## Architectural Review Board

### Meeting Minutes

### **ARB-85-2017 Certificate of Appropriateness**

**ARB-86-2017 Certificate of Appropriateness**  
**Certificate of Appropriateness for new signage for Freshii located at 160 W Main St,**  
**Suite F. (PID: 222-000067)**  
**Applicant: Signcom Inc, c/o Bruce Sommerfelt**

Source: Front elevation along Main Street from submittal from Market Street Building Design

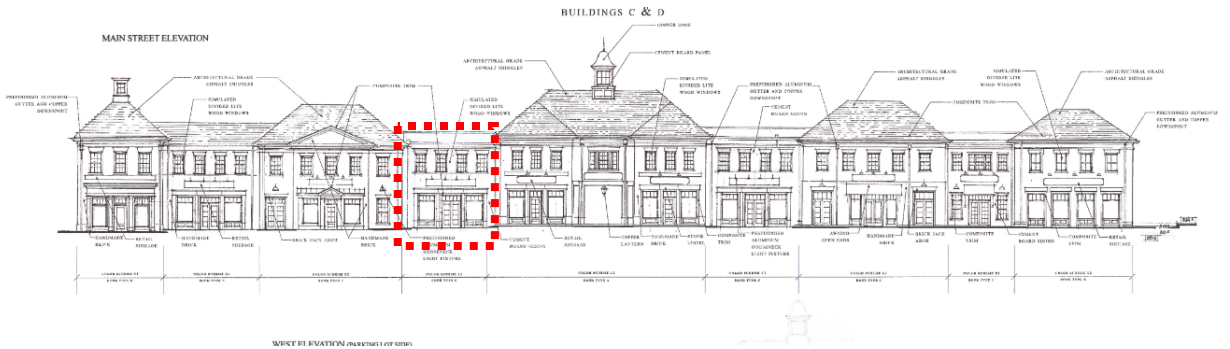
- The patio will be located on either side of the Freshii doorway on the Main Street elevation. When facing the door the patio portion on the left will be 15' x 11' 6" and the portion on the right of the door will be 15' x 11' 8". The plan proposes to outline the patio space with new and existing brick pavers to define the outdoor dining space and match the existing landscape beds.

- The applicant has not submitted a landscape plan. The city's landscape architect has reviewed the plans and recommends the plantings be in the same vernacular as the original plantings as shown below. Staff recommends a condition of approval requiring the final brick edging detail and landscaping are subject to the city landscape architect's approval.

- The proposed patio area matches the width of the storefront and appears to be an appropriate size. With staff’s landscaping recommendation, the patio will appear to be designed as part of the original site design.

3. *The distinguishing original qualities or character of a building, structure, site and/or its environment shall not be destroyed.*
    - The patio is an addition that will serve to enhance the original character of the structure. The applicant proposes to continue the brick paver edging pattern/detail.

- 1. The city’s landscape architect’s design should be implemented subject to staff approval, including minor design modifications.
- 2. Final landscaping plan is subject to staff approval.

Source: Front elevation along Main Street from submittal from Market Street Building Design

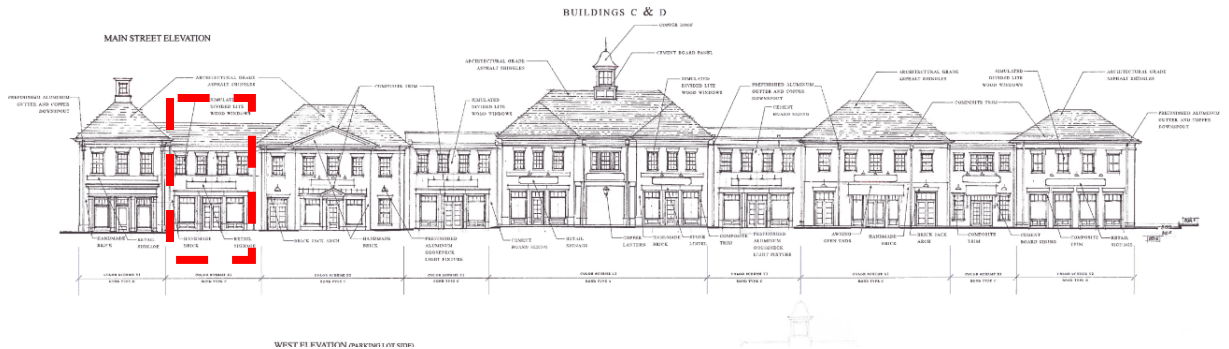
- City sign code Chapter 1169.16(h) permits a maximum area of 33' 8" square feet based on the building's frontage and allows one wall sign per business entrance and requires a minimum sign relief of one inch. External illumination is allowed. The applicant proposes two wall signs with the same, following dimensions:

- a. Size: 2' x 14' [meets code].
    - b. Area: 28 square feet [meets code].
    - c. Location: fastened flush to the storefront face above the primary entrance facing the parking lot and Main St. [meets code].

- d. Lighting: external lighting [meets code].
    - e. Relief: 2 inches [meets code].
    - f. Colors: green with white lettering and border (total of 2) [meets code].

- g. Lettering Height: 17 inches [meets code]
  - The sign will read "Freshii Eat. Energize."
  - The proposed sign has cove-cut edges with scalloped corners.

- One sign is located above the primary entrance to the business on the Main street elevation of the building.
  - The second sign is located above the entrance to the business from the parking lot (west) elevation of the building.

- According to C.O. 1169.12(b)(1) signs are not allowed to block portions of architectural detailing, windows, entries, or doorways. The sign's mounting location does not appear to block architectural detailing on either elevation.

Move to approve Certificate of Appropriateness for application ARB-86-2017 for new wall signs for Freshii.
